Re: EB-2014-0295

As described in Section 23 of the OEB's *Rules of Practice and Procedures*, please accept this document as a summary of my comments and concerns on Suncor's Application to construct distribution infrastructure for their Cedar Point wind project on the Town of Plympton-Wyoming's road allowances.

EB-2014-0295

**Location Map- Suncor Energy Products Inc.  
Proposed 34.5 kV Distribution System Within  
The Town of Plympton-Wyoming**

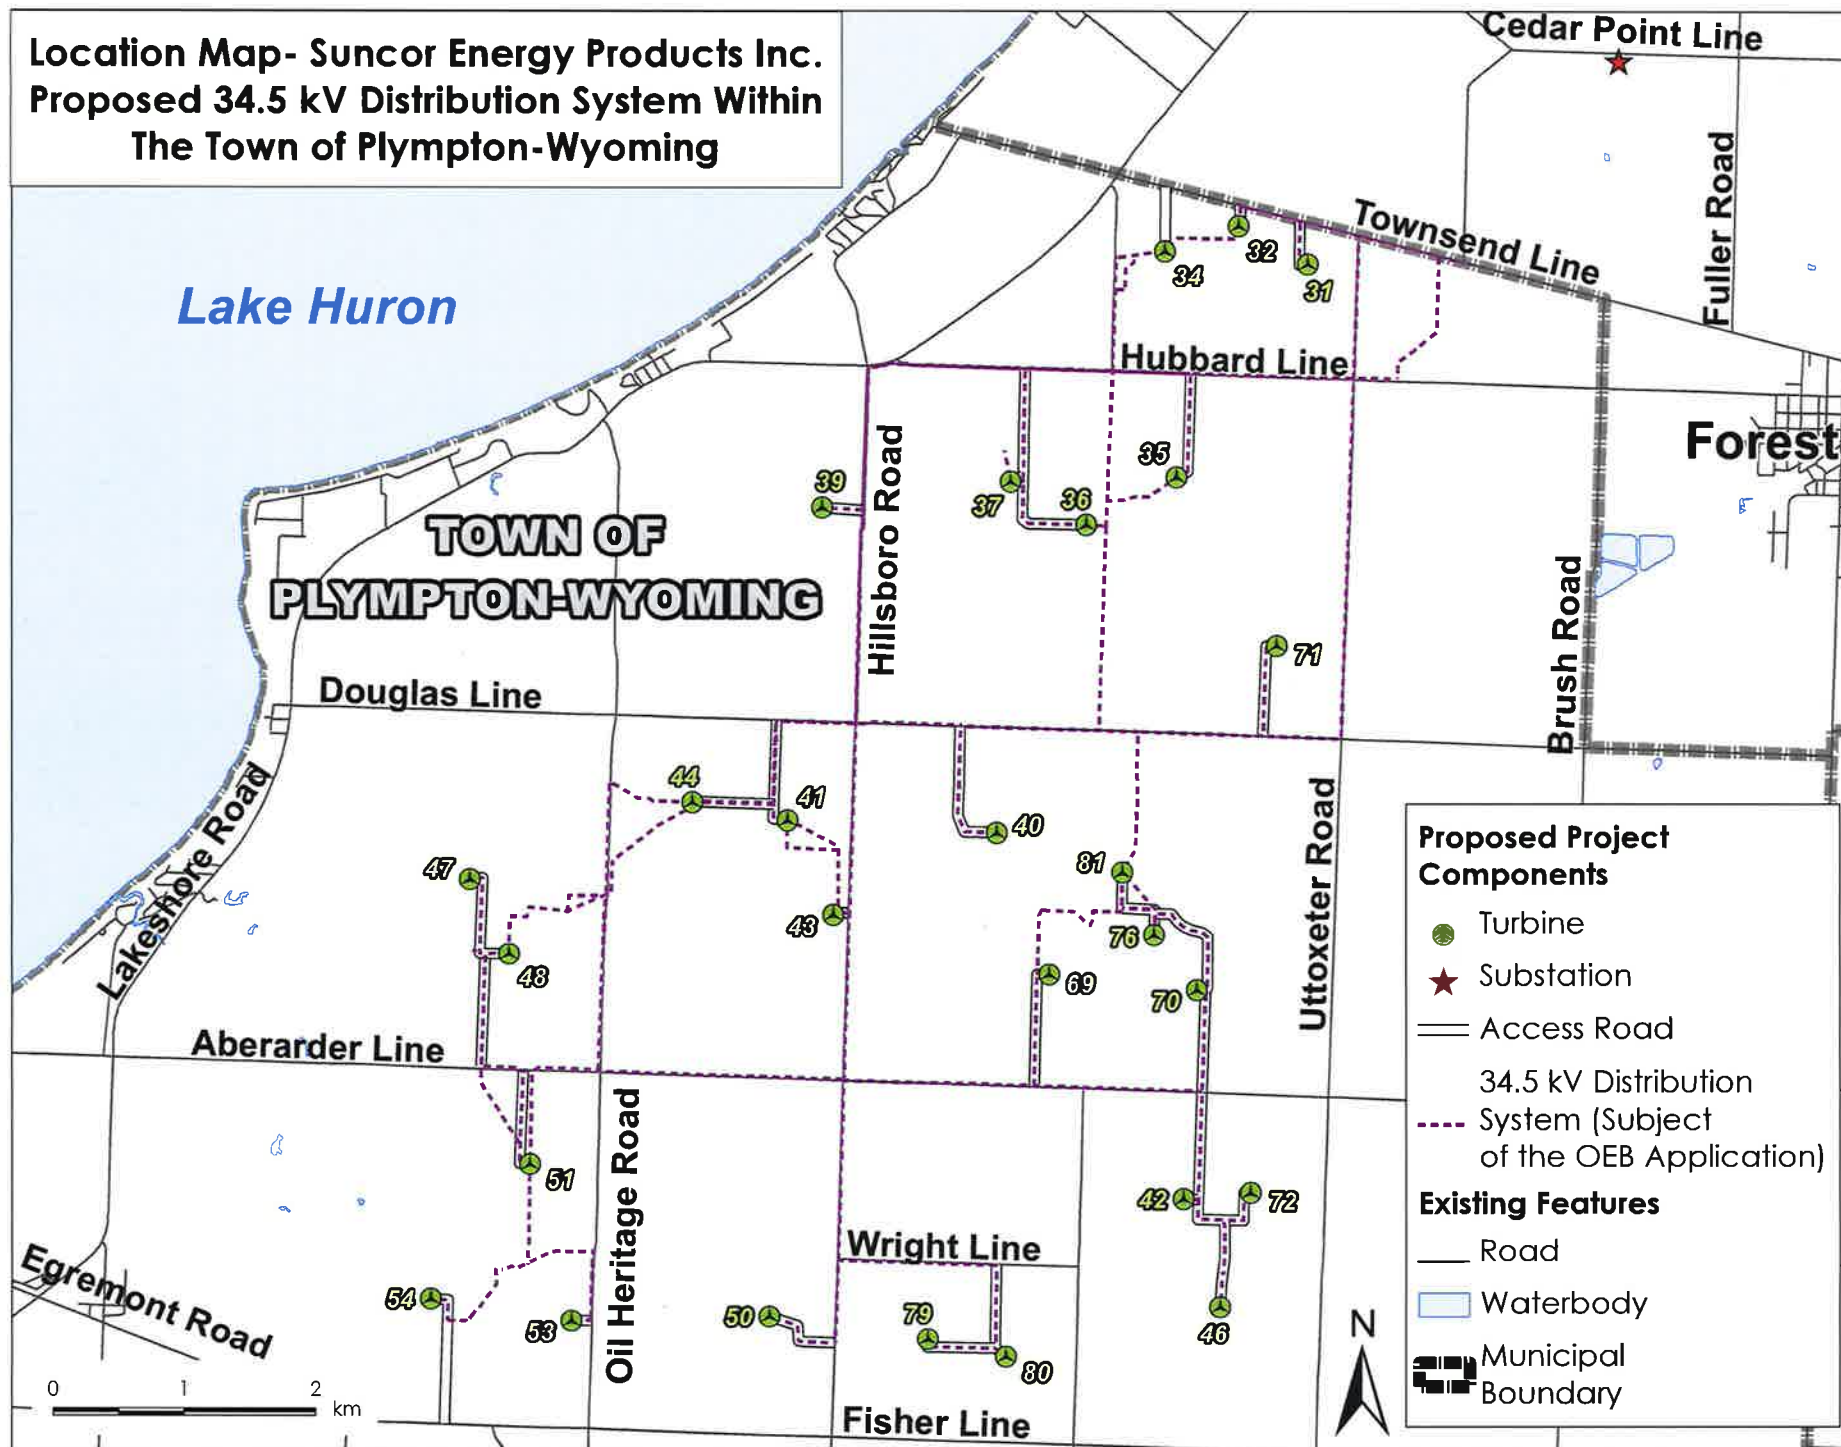
There are significant discrepancies in the location of the distribution facilities between Suncor's Notice of Application, as shown on the map, page 2, and the map in Appendix A of this Exhibit B, Tab 2, Schedule 1 and in Appendix L of Exhibit B, Tab 4, Schedule 1

1.1: Suncor has not confirmed that the diagram in their Application is the correct version and that the diagram in their Notice is no longer accurate.

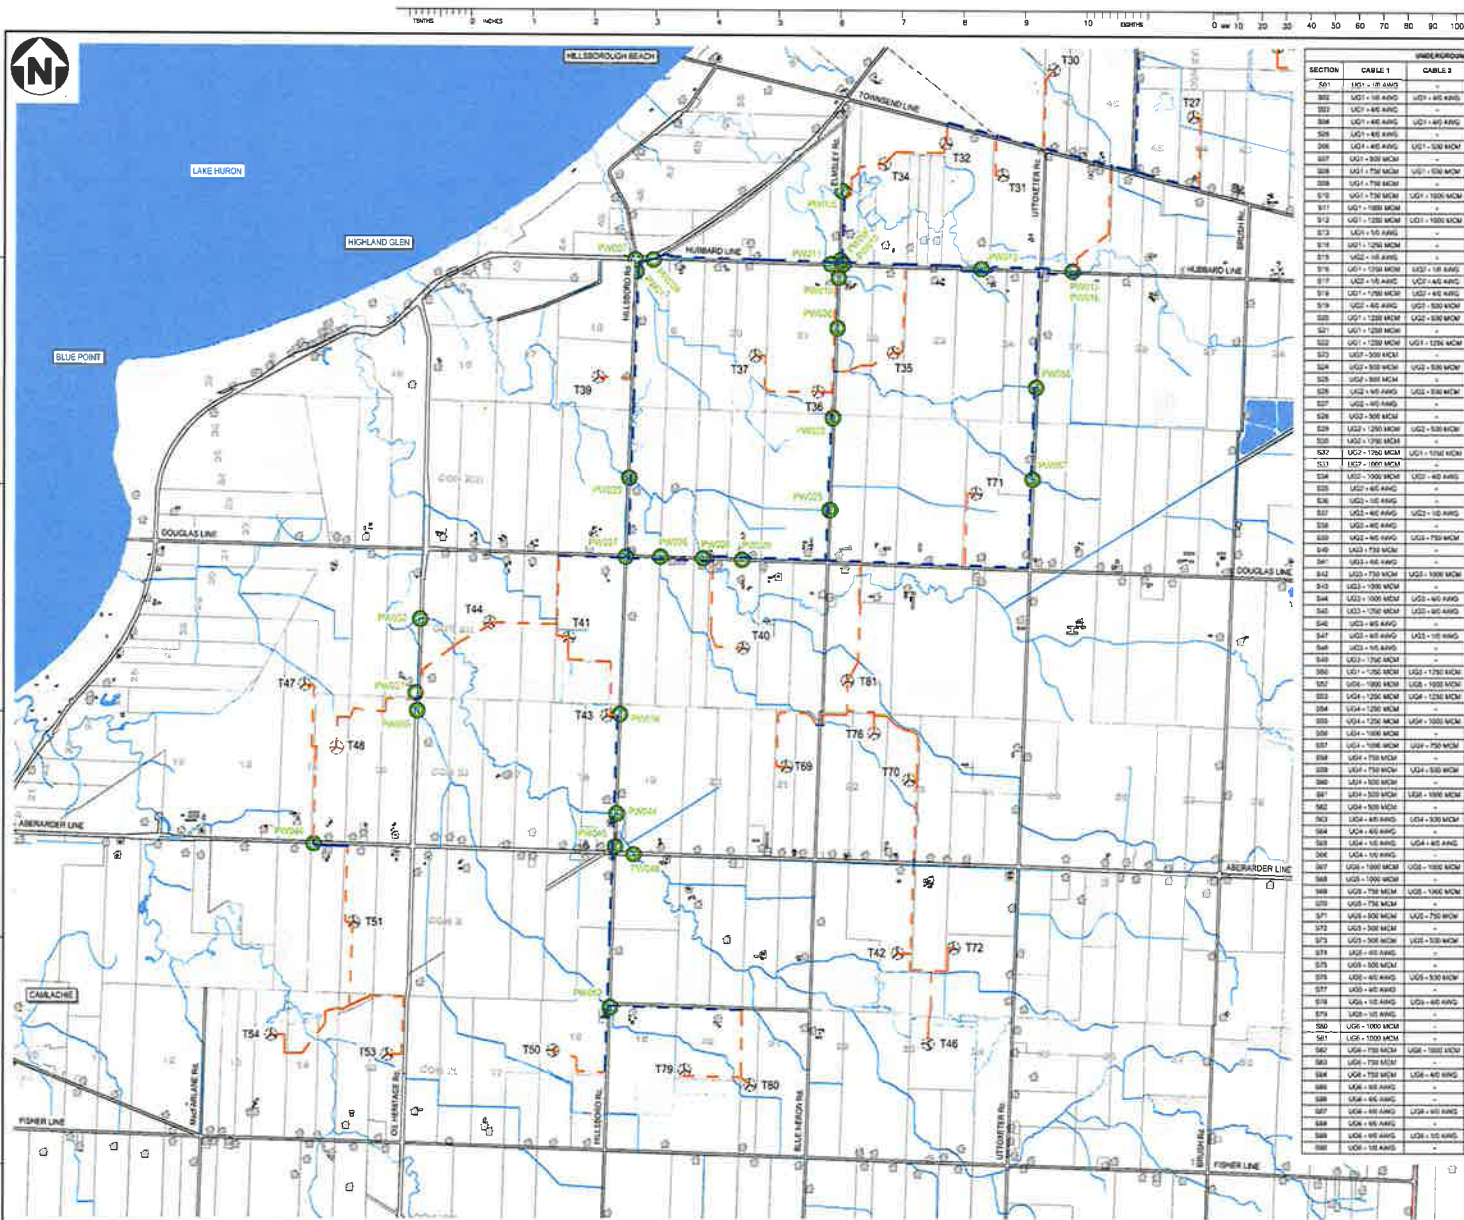
1.2: Suncor has not identified the current final and alternate sites, nor have they indicated which portions of the distribution facility would NOT be required due to the removal of the alternate sites from the project plan.
